PRODUCT CHANGE NOTIFICATION

PCN No.: EC-20250804-PCN-27	**PCN Doc No.:** PCN-202508-036	**Date Issued:**	8/13/2025
Part Number or Series: PH2-XX-TA-SMT-PP-T/R		**PCN Effective Date:**	N/A
Customer: (If applicable)		**P/O No.: (If applicable)**	N/A
Type of Change:	■ Mfg location Change / Qualification / Country of Origin (COO) ■ N/A	**Last Time Buy Date:**	Original P/N Still active
Traceability Marking/Date code:		**Last Time Ship Date:**	
Replacement Part Number: PH2-XX-TA-SMT-Y-PP-T/R		**Sample Availability Date:**	8/13/2025

Change Description: Mfg production location chage from Taiwan to Malasia

Before Change

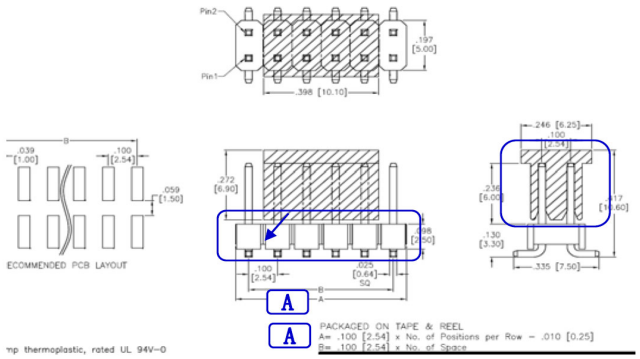
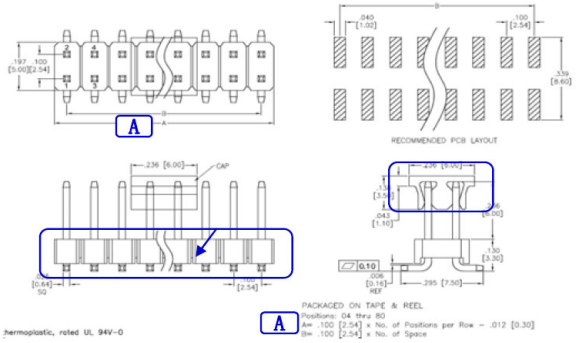
Impact of Change: P/N change, slight dimensional difference, different PP cap and appearance

变更前Before the change:
1、外观~如上图;
Appearance ~ As shown in the above picture;
2、尺寸Size:
A) A=.100[2.54] * No. of Positions per Row - .010[0.25]
3、CAP 外观与尺寸~如上图
CAP appearance and size~as shown in the above picture;

变更后After the change:
1、外观~些微不同;
Appearance ~ Slightly different;
2、尺寸Size:
A) A=.100[2.54] * No. of Positions per row - .012[0.30]
3、CAP 外观与尺寸~有差异;
CAP appearance and size~There are differences;
